Petition to Amend

Amendment No. 11

CEC License for the
Pastoria Energy Facility
Lebec, California
(99-AFC-7C)

February 2016

FIGURE 2-1
General Arrangement
 Pastoria Energy Facility Petition to Amend No. 11
 Lebec, California

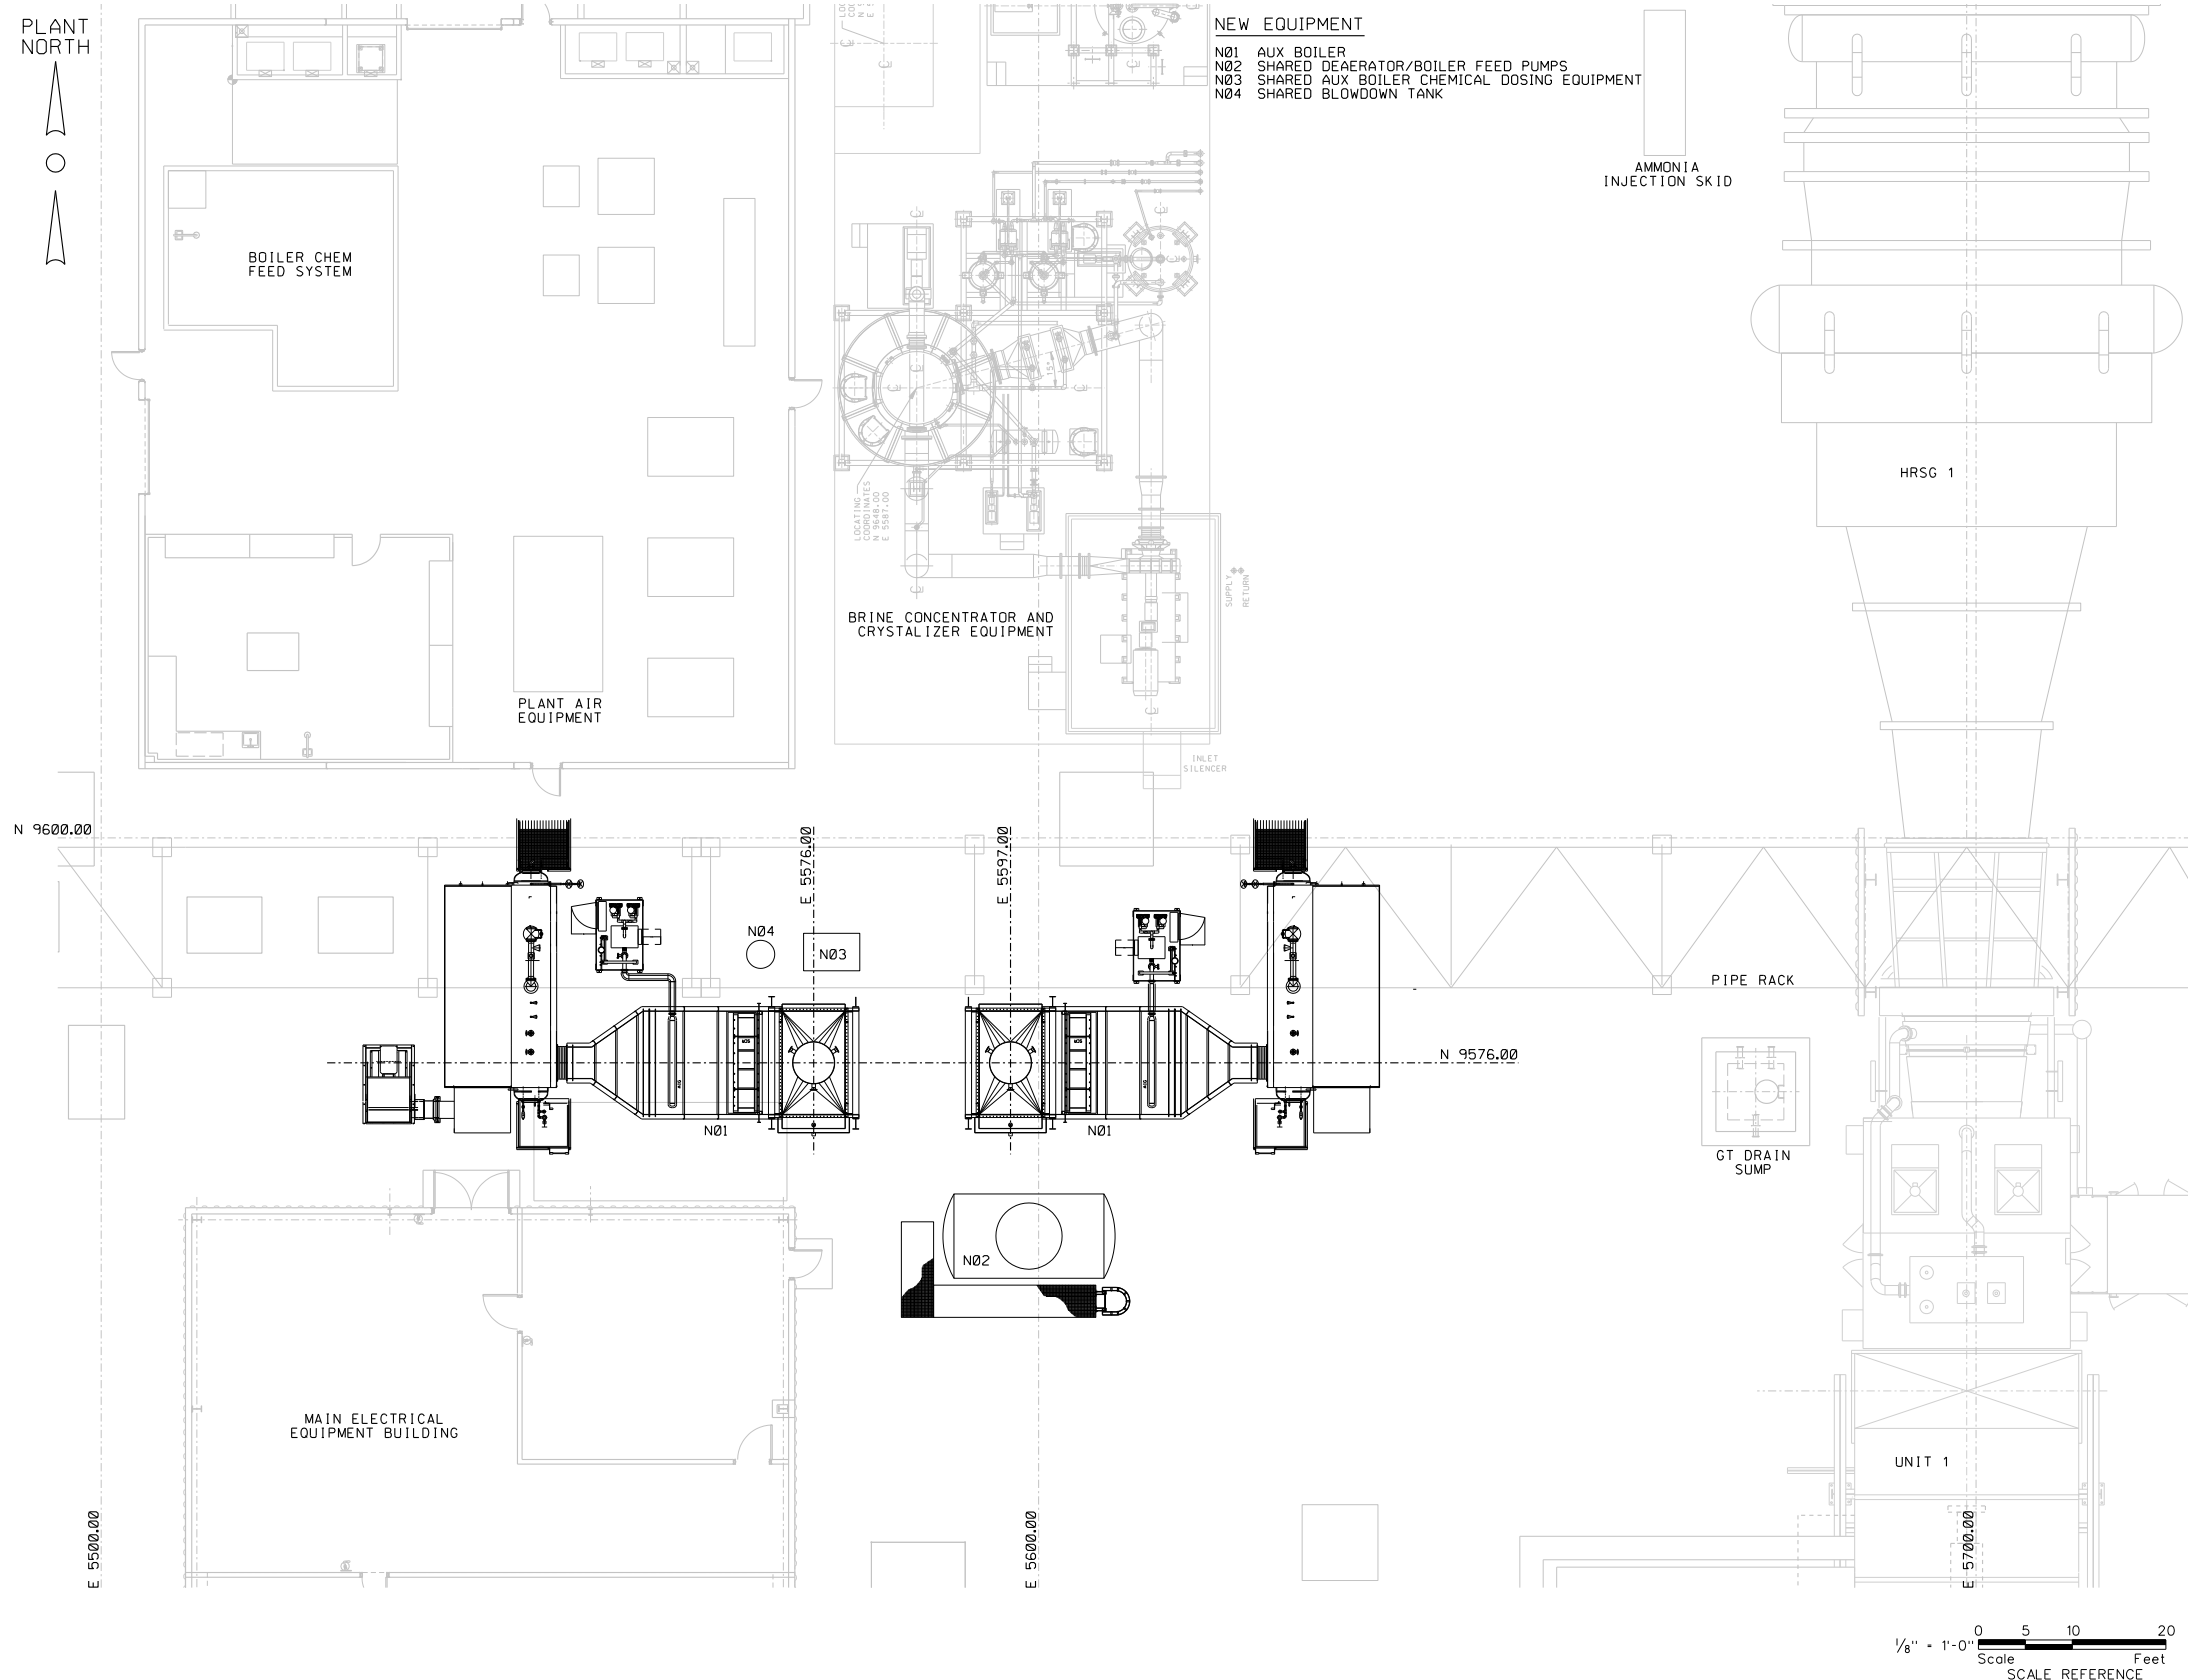
The proposed equipment modifications are described below. The location of the equipment modifications is shown in Figure 2-1, General Arrangement. These modifications will be made on site, within the existing project fenceline.

FIGURE 2-2
Typical Auxiliary Boiler
Source: Rentech Boiler Systems

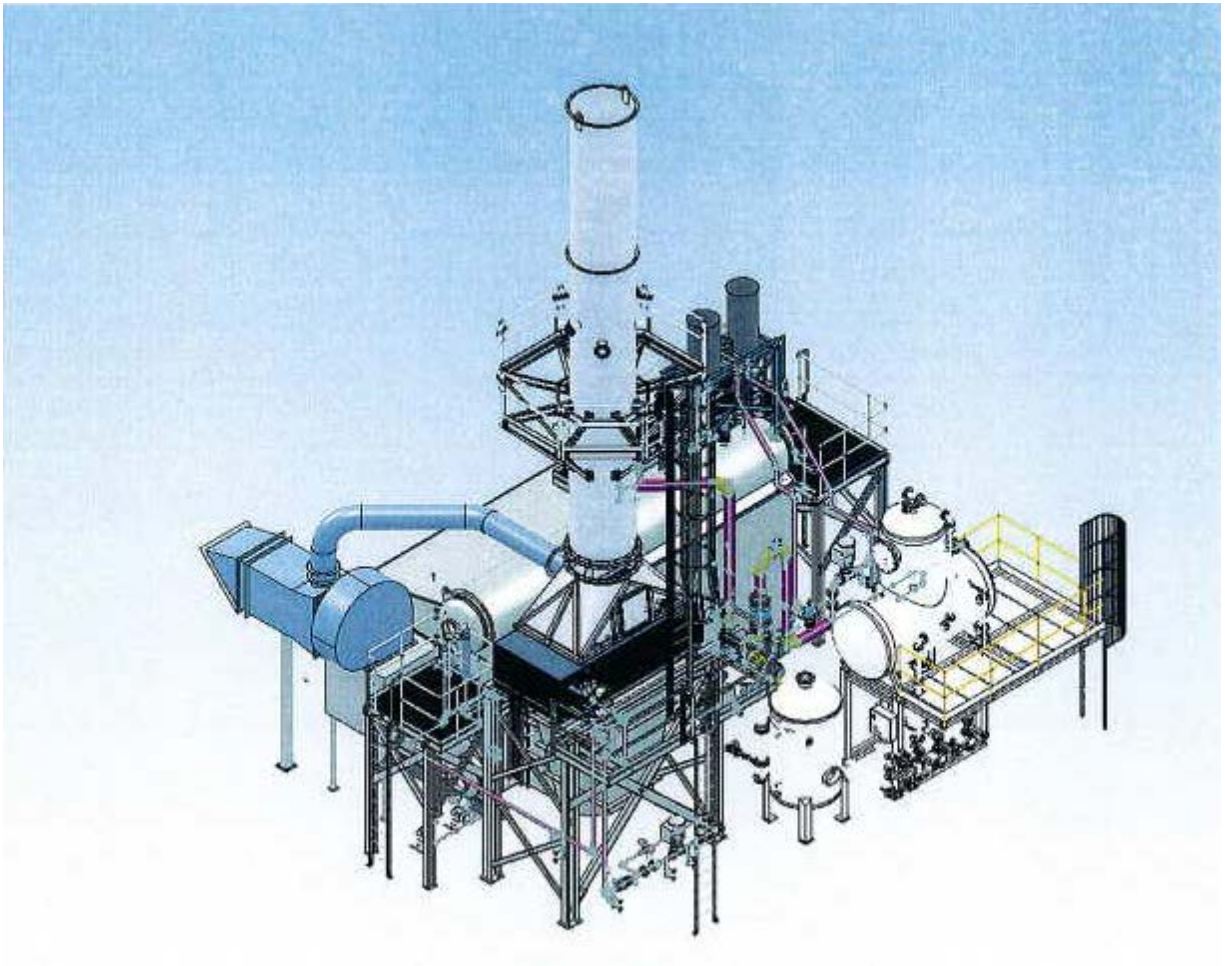
Addition of two natural-gas-fired auxiliary boilers will allow the plant to keep certain operating systems sufficiently warm to reduce startup times. A conceptual drawing of the boiler is shown below in Figure 2-2. Steam from the auxiliary boilers will be used for steam seals, HRSG sparging, and hotwell heating. The auxiliary boilers will allow the project to maintain condenser vacuum overnight or to pre-establish condenser vacuum prior to starting the combustion turbines. They will also allow the project, when starting, to ramp up combustion turbine operation without holds by enabling turbine bypass valve operation immediately upon HRSG steam production. The auxiliary boilers will also provide a source of steam to start the fuel gas heater, and for high-pressure drum pre-warming on cold starts.

The boilers are rated at 83.7 percent system efficiency (high heating value), using about 91.38 million Btu (MMBtu) per hour of natural gas (at a heating value of 23,235 Btu/lb, for a fuel flow of 4185 lb/hr). Each boiler will provide 75,000 pounds of steam per hour. The boilers will use selective catalytic reduction (SCR) technology to achieve oxides of nitrogen (NO_x) emissions of 0.006 lbs/MMBtu (5 ppm). Each boiler will include a 60-foot-tall exhaust stack, which will be significantly shorter than the existing 150-foot-tall HRSG stacks. The boilers emit carbon monoxide (CO) at a maximum of 0.037 lb/MMBtu (50 ppm), particulate matter (PM-10 and PM-2.5) at 0.007 lbs/MMBtu, volatile organic compounds (VOC) at 0.004 lbs/MMBtu (10 ppm), and sulfur oxides at 0.003 lbs/MMBtu.
